**TOWN OF NEWBURGH
PLANNING BOARD
TECHNICAL REVIEW COMMENTS**

PROJECT: RAM HOTELS, INC.
PROJECT NO.: 16-21
PROJECT LOCATION: SECTION 97, BLOCK 2, LOT 37
REVIEW DATE: 13 MARCH 2017
MEETING DATE: 16 MARCH 2017
PROJECT REPRESENTATIVE: MECURIO-NORTON-TAROLLI-MARSHALL

**Grading Plan - South
for
RAM Hotels**

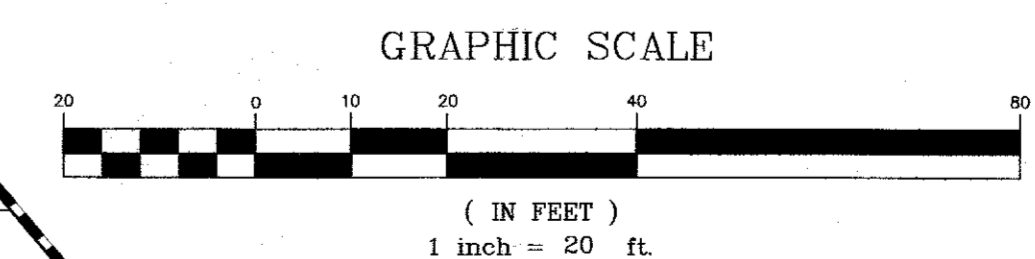
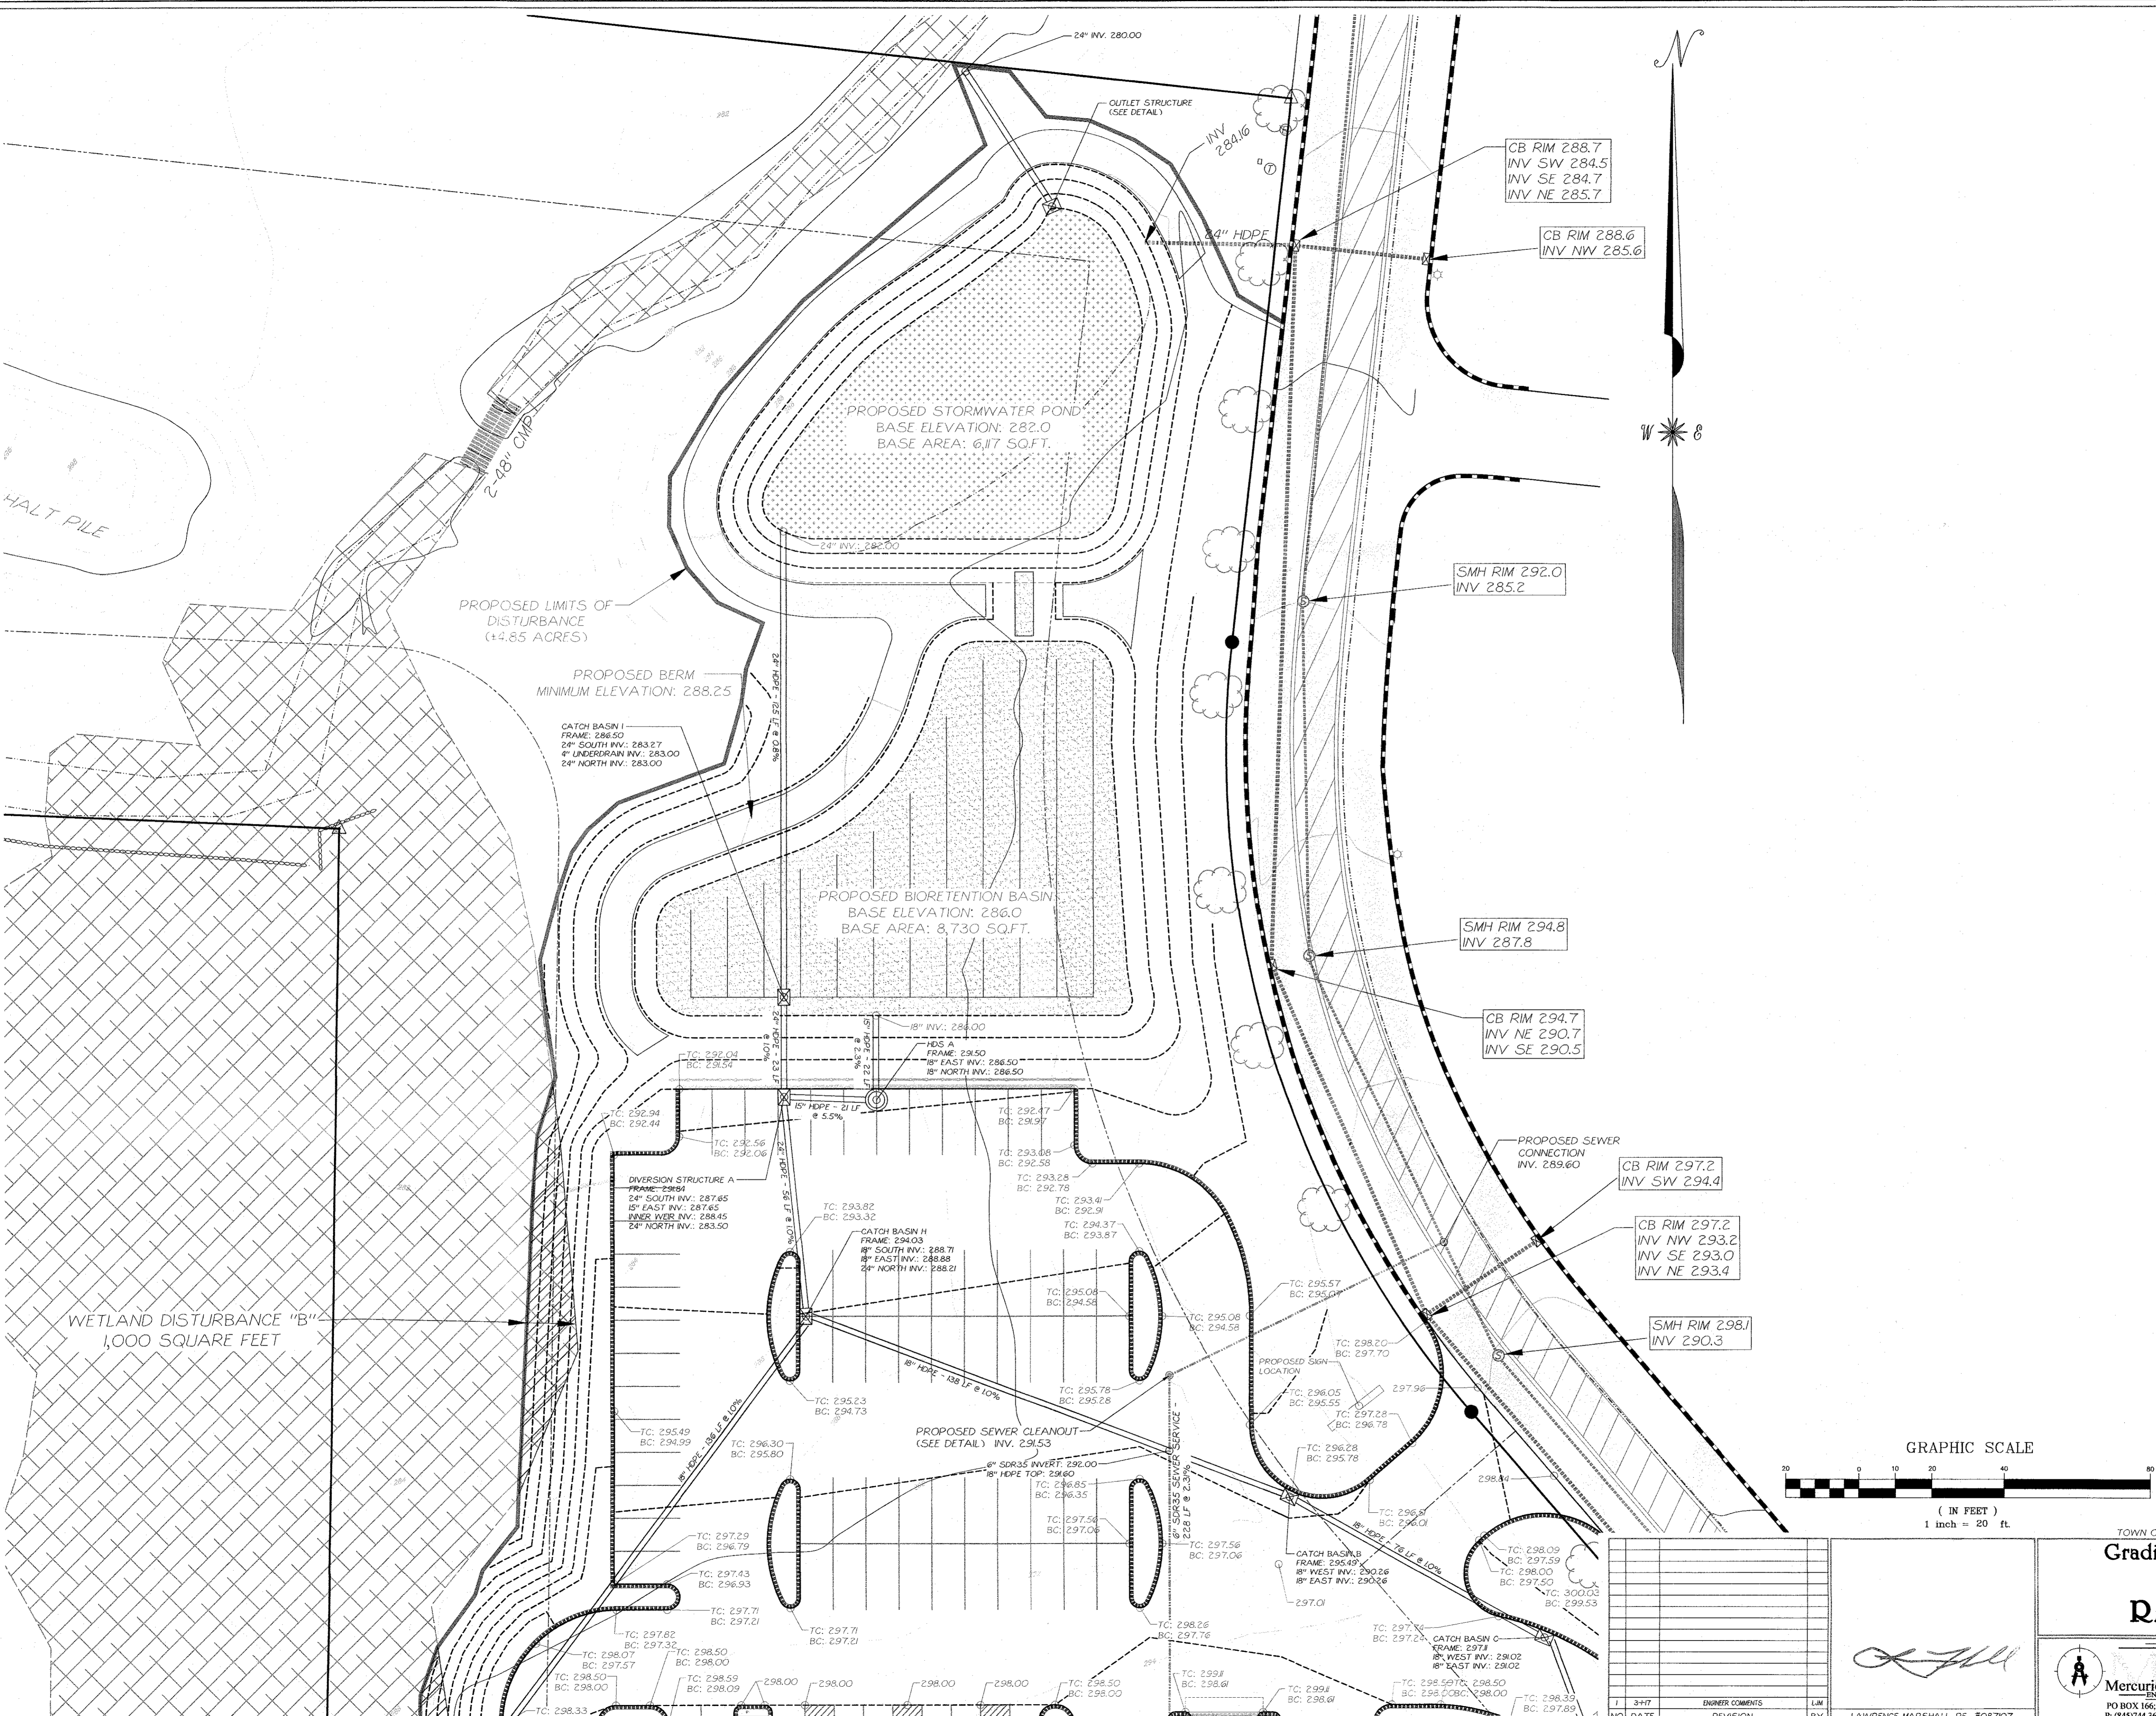
2. For clarity sheets 3 & 4 of 9 should be identified as Utility and Grading plans.
3. A review by the Code Enforcement Department regarding location of onsite hydrants should be provided. Applicant's representative's response letter identifies that this meeting is to be scheduled.

Detail Sheet
for
RAM Hotels, Inc.

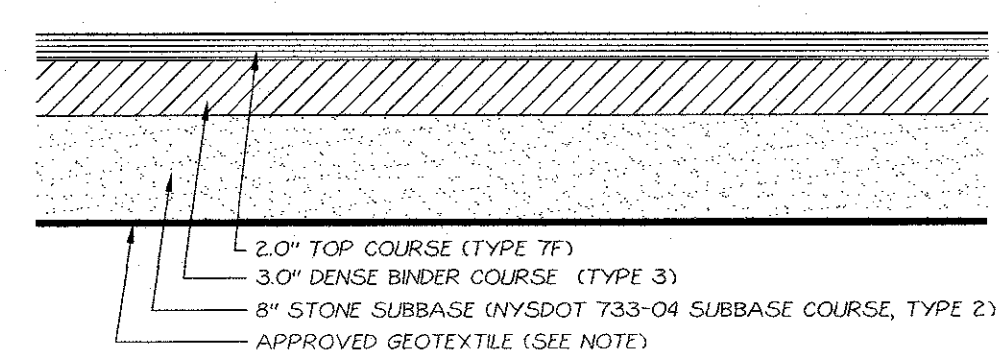
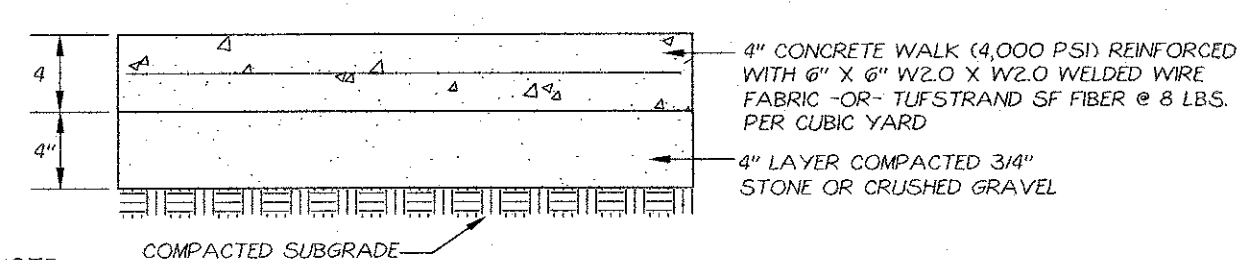
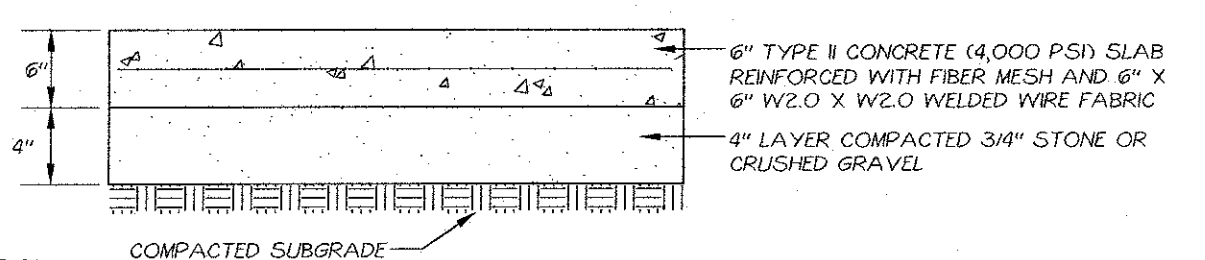
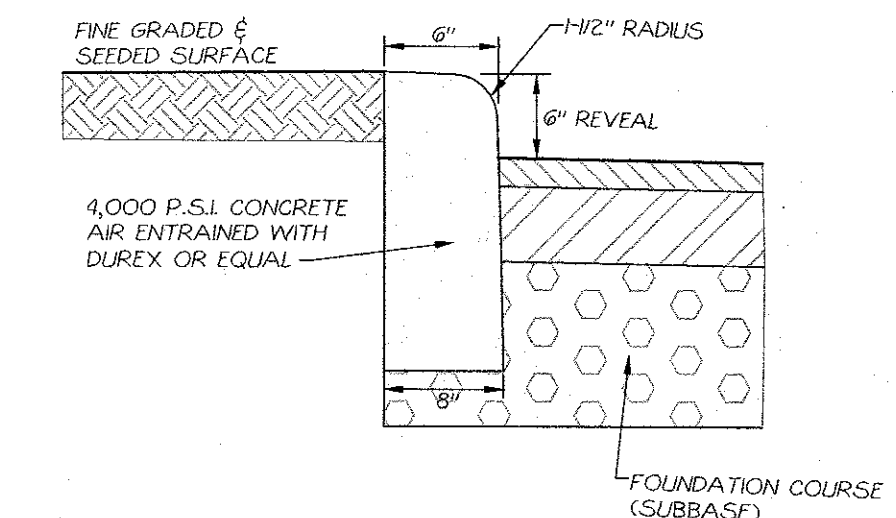
4. A City of Newburgh Flow Acceptance letter is outstanding and must be received prior to any approvals.
5. Several types of pavement are identified on the detail sheet. A plan identifying the location of the various pavements proposed for the parking lot should be provided or the details which are not to be used should be removed from the plans.

Typical Hydrodynamic Separator Detail
NOT TO SCALE

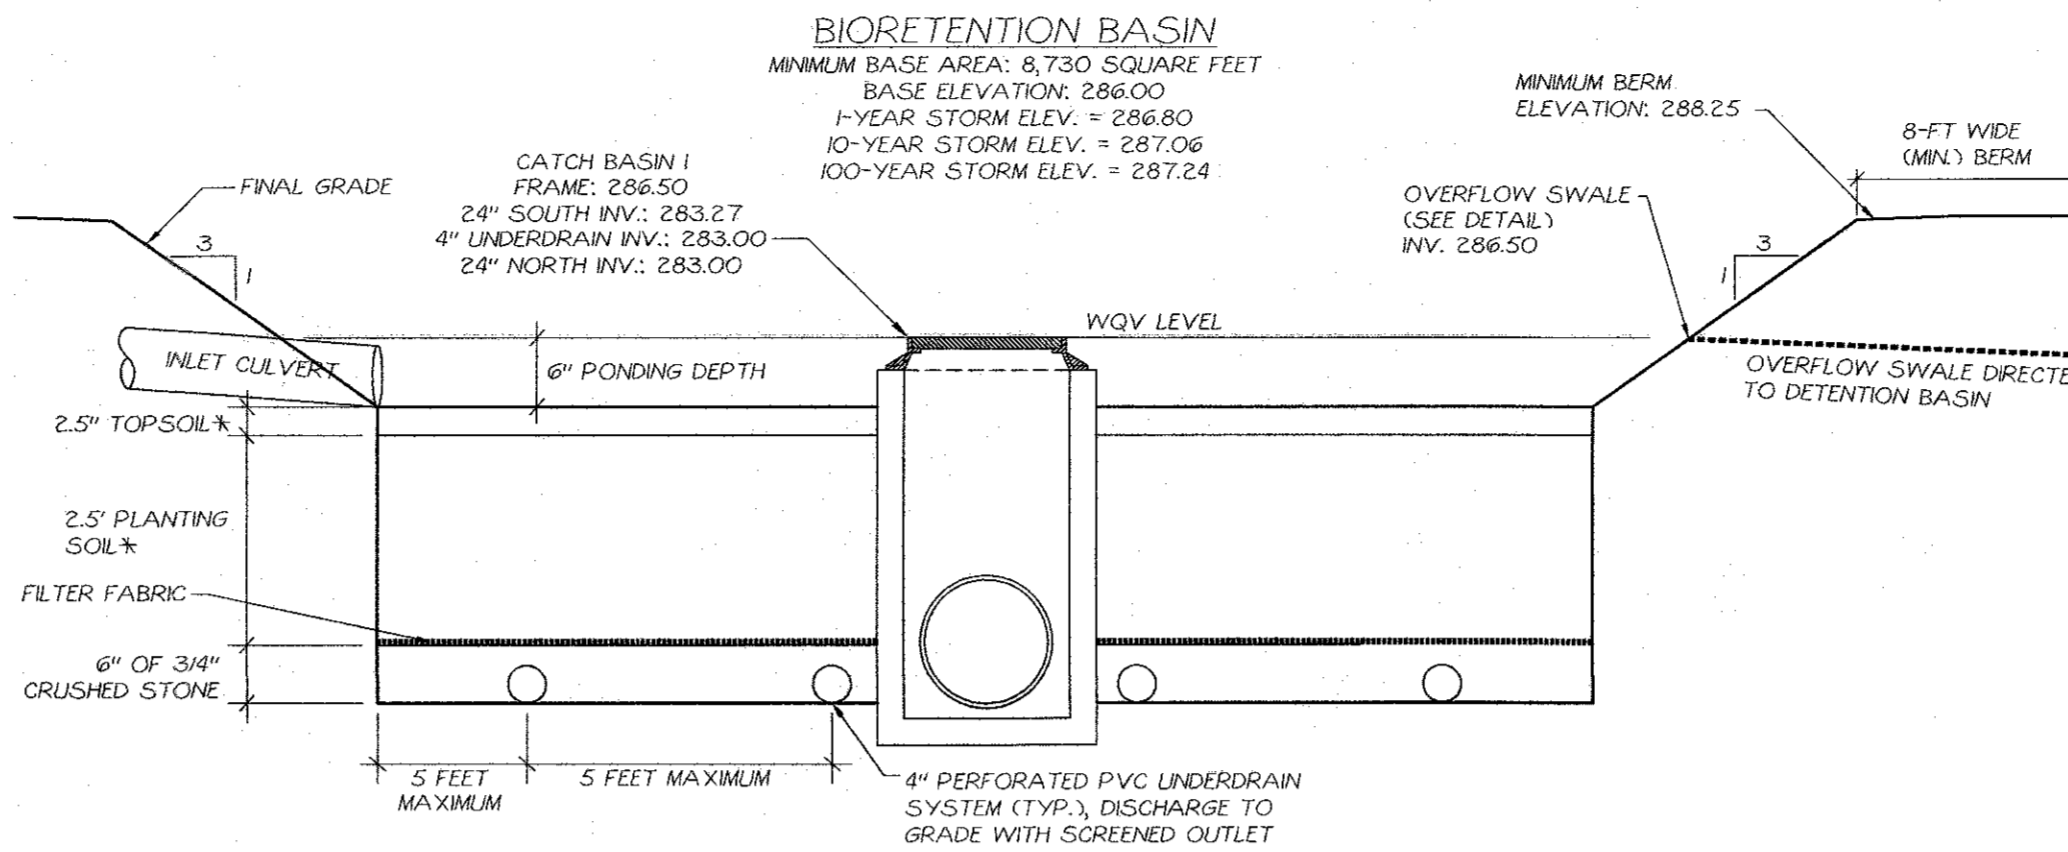
6. A stormwater control facilities maintenance agreement must be executed prior to final plan stamping.
7. We continue to have a concern about the point discharge to the proposed bio retention area from the HDS treatment structure.

Detention Basin 'A' Detail
NOT TO SCALE

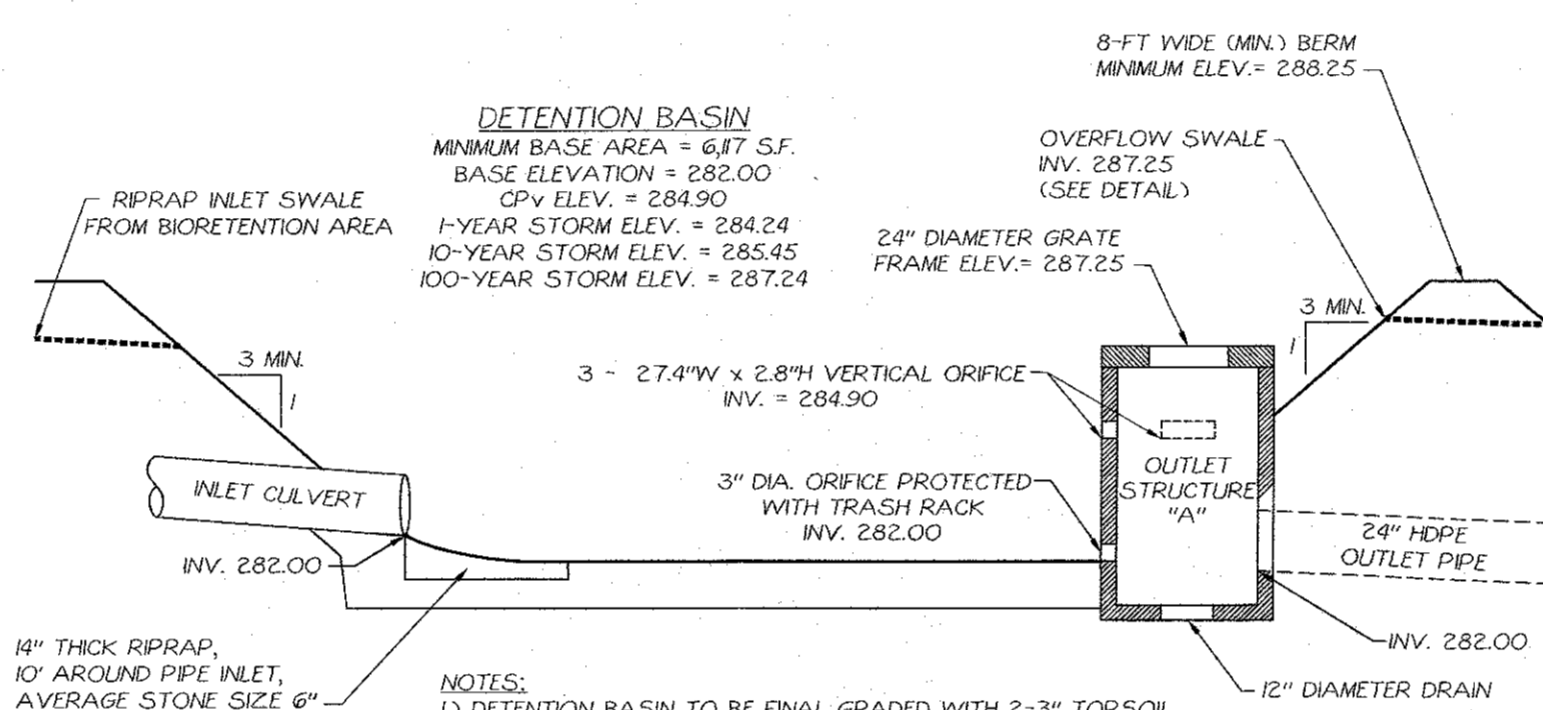
10. The Applicants representatives are requested to evaluate whether the proposed detention pond will be fenced. It is noted the existing wet detention pond is proposed to become a dry detention pond and only hold water during and immediately after storm events.
11. Typical sanitary sewer trench detail should identify similar language as the water detail regarding pavement replacement in paved areas.
12. Shared access agreement must be filed for the proposed driveway serving both lots. Cross grading easements are depicted on the lots. Mike Donnelly's comments on these must be received.

Gravel Diaphragm Detail
NOT TO SCALE

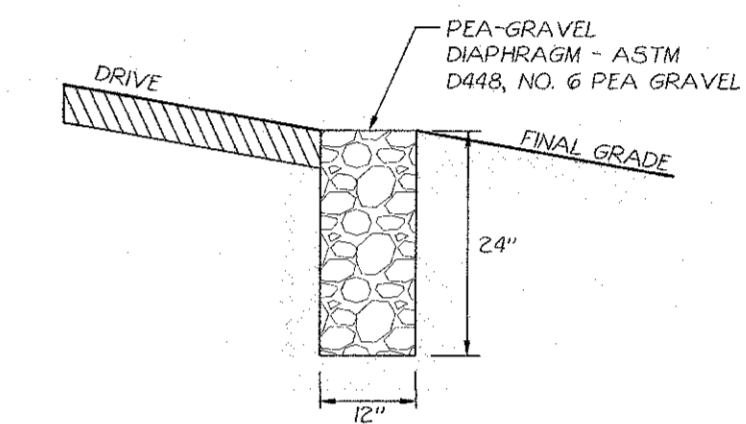
8. The Pea Gravel diagram is not depicted on the plans or bio retention detail.
9. Landscaping plans do not address landscaping of the bio retention and detention pond
